Access Compliance Report

Public Rights-of-Way

(Curb Ramps)

Intersection ID: 16140	Main Street: CEDARWOOD_LN	Cross Street: FARMINGDALE_DR	Location: NE
ADA ID: 1D821B8591D3	Ramp Type: PerpDiag	Initial Pass/Fail: Fail	Overall Compliance: No
Severity Score: 21.25			
Codes/Mitigation Info/Possible Solution		Field Measurements/Component Compliance

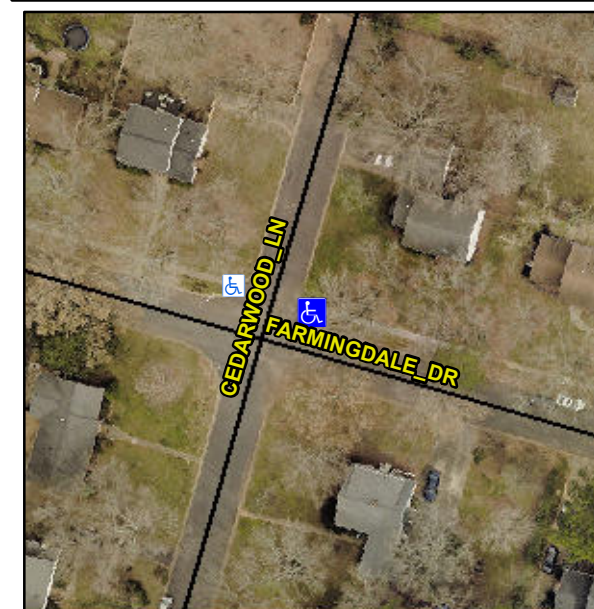
Not Found, R304.5.1, R304.2.2

Compliance	Description	Data	Compliance	Description	Data
N/A	Ramp Length (in)	33.0	No	Ramp Slope (%)	8.9
No	Ramp Width (in)	43.0	Yes	Ramp XSlope (%)	1.2
N/A	Flare Type LT	N/A	N/A	Flare Type RT	N/A
N/A	Flare Slope LT (%)	N/A	N/A	Flare Slope RT (%)	N/A
N/A	Flare Traversable LT?	N/A	N/A	Flare Traversable RT?	N/A
N/A	Landing Length (in)	N/A	N/A	DWS Provided?	N/A
N/A	Landing Width (in)	N/A	N/A	DWS Contrast?	N/A
N/A	Landing Slope (%)	N/A	N/A	DWS Length (in)	N/A
N/A	Landing X Slope (%)	N/A	N/A	DWS Full Width?	N/A
N/A	Landing Curb? (Y/N)	N/A	N/A	DWS Offset (in)	N/A
N/A	Shared Landing?	N/A			
N/A	Gutter Ponding?	N/A	N/A	Gutter Slope (%)	N/A
N/A	Gutter Lip Ht (in)	N/A	N/A	Gutter X Slope (%)	N/A
N/A	Painted X Walk1?	No	N/A	Painted X Walk2?	No
	X Walk 1 Direction	To NW		X Walk 2 Direction	To SW
N/A	X Walk 1 Width (in)	N/A	N/A	X Walk 2 Width (in)	N/A
	X Walk 1 Slope (%)	1.1		X Walk 2 Slope (%)	1.1
	X Walk 1 X Slope (%)	2.7		X Walk 2 X Slope (%)	2.4

Remove & Replace Curb Ramp With Two New Directional Ramps or Equivalent.
